# SERVICE BULLETIN

GO-KART #4  
APRIL 25, 1994

## BRACKET, BRAKE CALIPERS

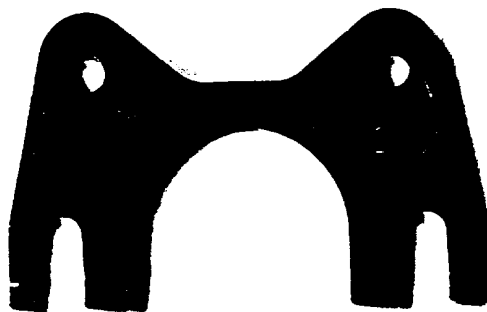
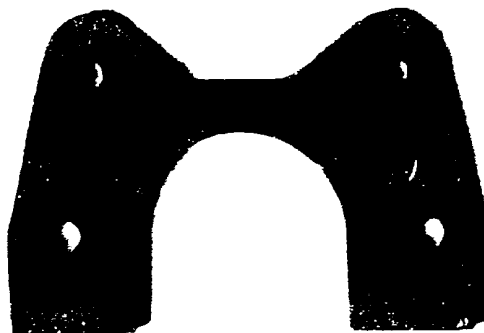
The brake caliper bracket lifts up off it's mounts. This is caused by the manufacturing of slots in the bracket. The updated bracket are now made with round mount holes.

OLD →

NEW →

Remove old caliper bracket and install updated part supplied at no charge.

Parts stock has been exchanged and there is no change to the part number.  
Part # 01087
